### D.6.2.4

#### Proposed Revision to ACI 318-02 Appendix D:

Fig. RD.6.2.4 - Shear in narrow ( $c_{2,\max} < 1.5c_1$ ), thin ( $h < 1.5c_1$ ) members

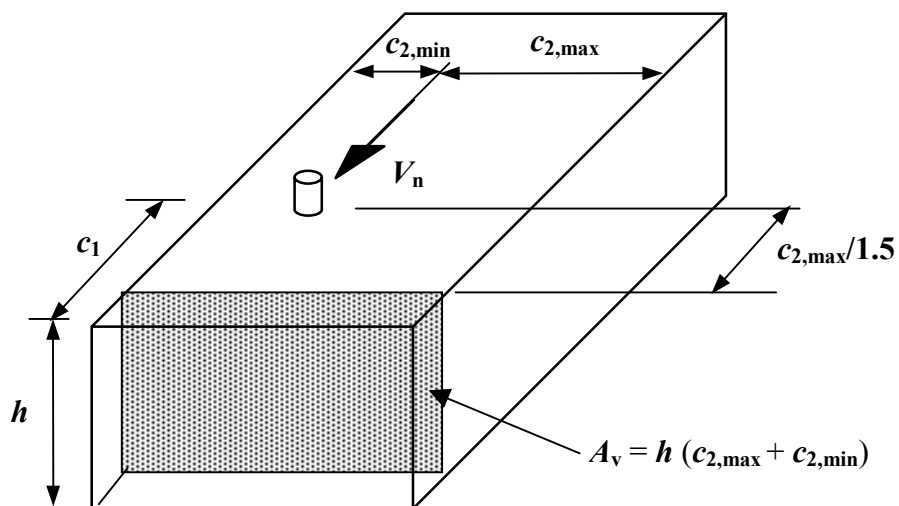
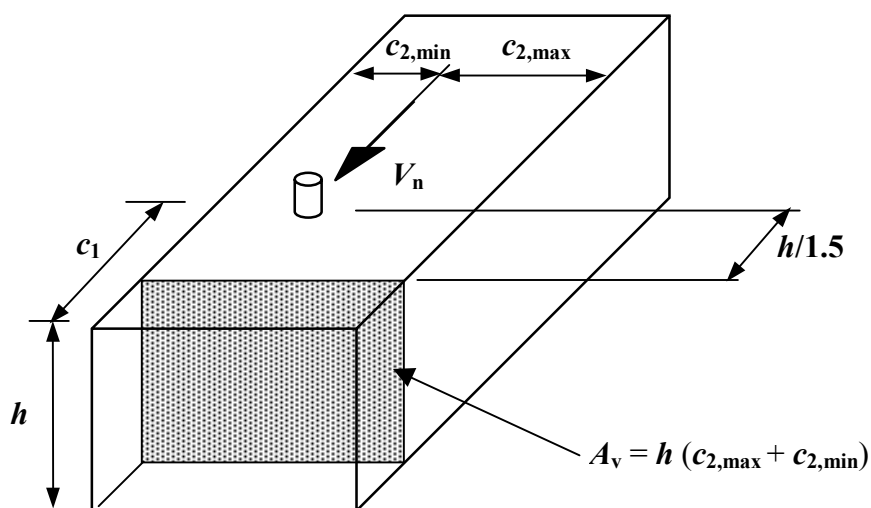
Section D.6.2.4 of ACI 318-02 deals with a very unusual condition where the shear is directed toward a free edge but there are two other close edges perpendicular to the applied load and the member thickness is less than 1.5 times the edge distance that the shear is directed toward. Although an infrequent occurrence, the current wording of D.6.2.4 has caused concern and rightly so. There was a change back in 1997 that dropped a term from this section unintentionally. The 1997 CB 30 wording, the proposed revision to D.6.2.4, and a possible new figure are provided below.

**RD.6.2.4** – For anchors in a narrow ( $c_{2,max} < 1.5c_1$ ), thin ( $h < 1.5c_1$ ) member influenced by three or more edges where any edge distance is less than  $1.5c_1$ , the shear breakout strength computed by the basic CCD Method, which is the basis for Eq. (D-23) and (D-24), gives safe but misleading results. These special cases were studied for the  $\kappa$  Method<sup>D.14</sup> and the problem was pointed out by Lutz<sup>D.20</sup>. Similar to the approach used for tensile breakouts in D.5.2.3, a correct evaluation of the capacity is determined if the value of  $c_1$  to be used in Eq. (D-22) to (D-27) is limited to  $c_{2,max}/1.5$  if  $c_{2,max} > h$  or  $h/1.5$  if  $c_{2,max} < h$ . This is shown in Fig. RD.6.2.4.

**D.6.2.4** - For the special case of anchors in a narrow ( $c_{2,max} < 1.5c_1$ ), thin ( $h < 1.5c_1$ ) member influenced by three or more edges, the edge distance  $c_1$  used in Eq. (D-22), (D-23), (D-24), (D-25), (D-26) and (D-27) shall be limited to  $c_{2,max}/1.5$  if  $c_{2,max} > h$  or  $h/1.5$  if  $c_{2,max} < h$ .

$c_{2,\max} > h$  : Use  $c_{2,\max} / 1.5$  for  $c_1$  in Eq. (D-22) to (D-27)

$c_{2,\max} < h$  : Use  $h/1.5$  for  $c_1$  in Eq. (D-22) to (D-27)
